E4981A-04A

Information Only Service Note

E4981A Capacitance Meter

A31 Digital Board Replacement Procedure

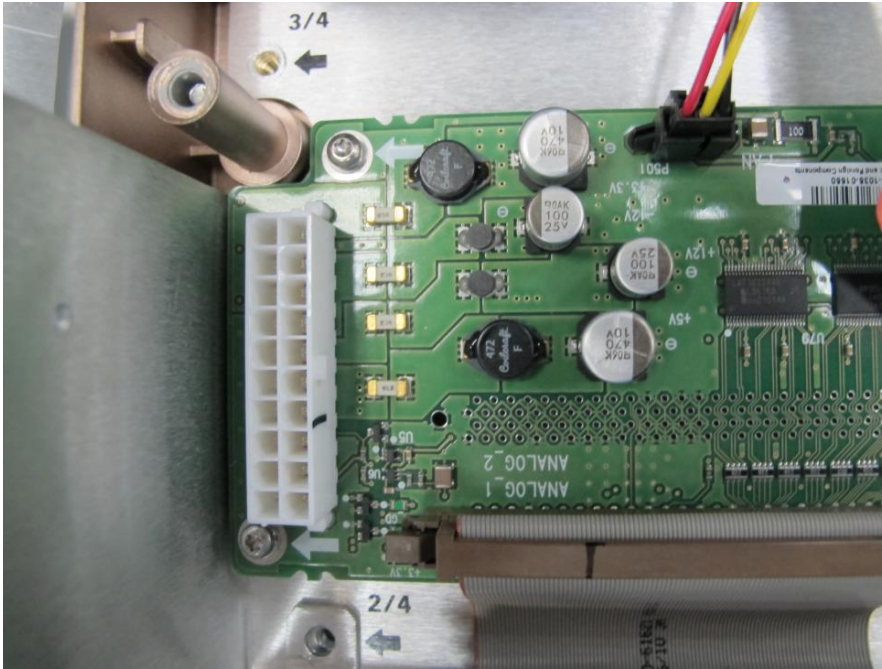
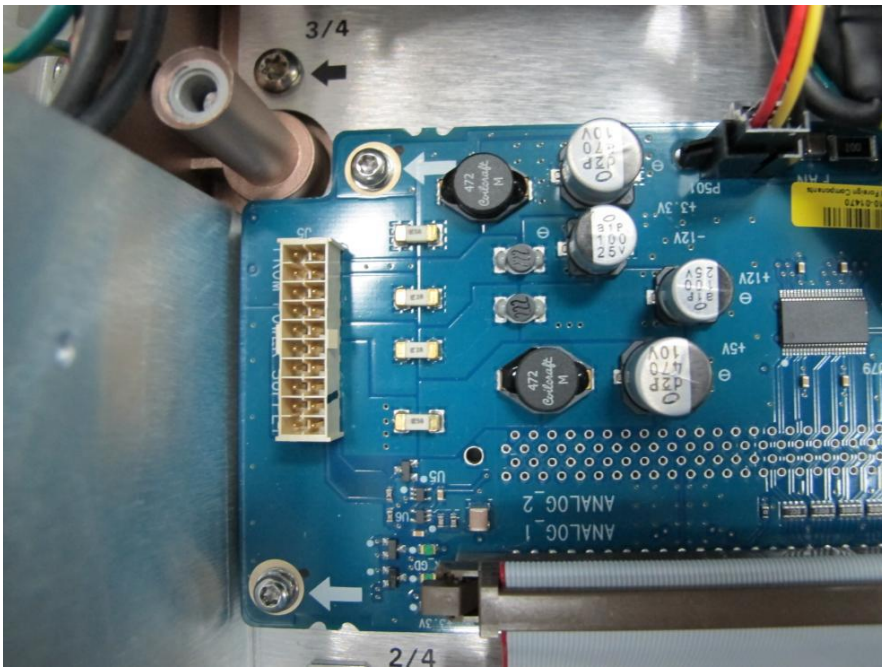
When repairing E4981A instrument A31 Digital Board, order E4980-66661 Printed Circuit Board Assembly, Pb-free, EXM DIGITAL & E4980-61627 Power cable assembly. (E4980-66631 has been obsolete) Power supply cable assembly needs to be replaced as E4980-66661 is having different connector with previous board E4980-66531.

NOTE: New A31 Digital board **E4980-66661** connector is different dimensionally. When replacing the Digital Board, it is required to replace the **E4980-61627** Power cable assembly as well. Power supply unit could be re-used and not required to be replaced. (E4980-66631 has been obsolete).

Figure 1- 1

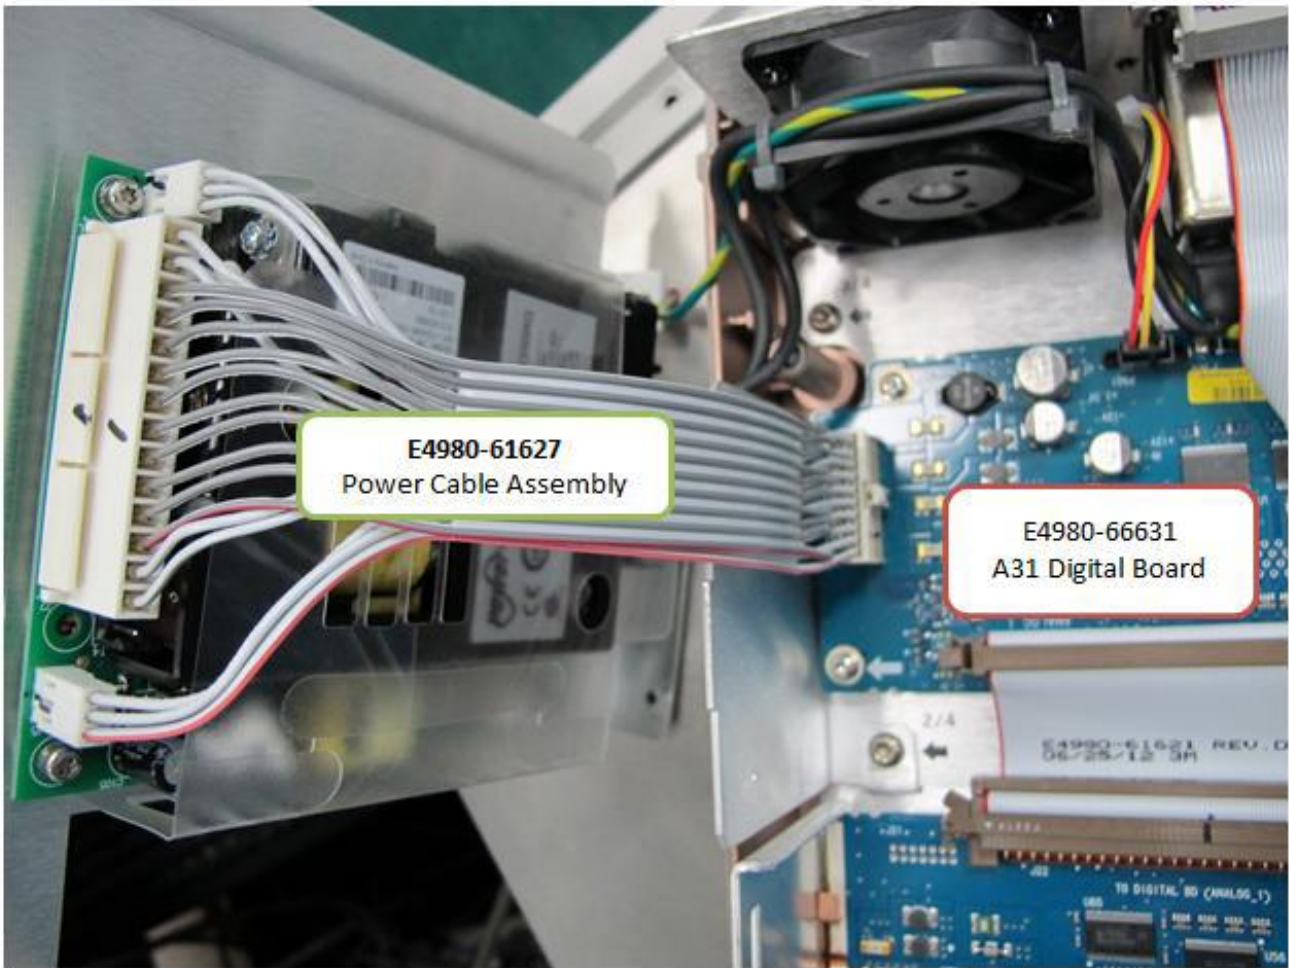
1. Refer to service guide for the removal procedure – Chapter 6- “A31 Digital Board Assembly Replacement”
2. Install the A31 Digital board **E4980-66661** onto the unit as shown in figure 1-1.
3. Connect the power cable assembly **E4980-61627** from power supply unit to A31 Digital board.
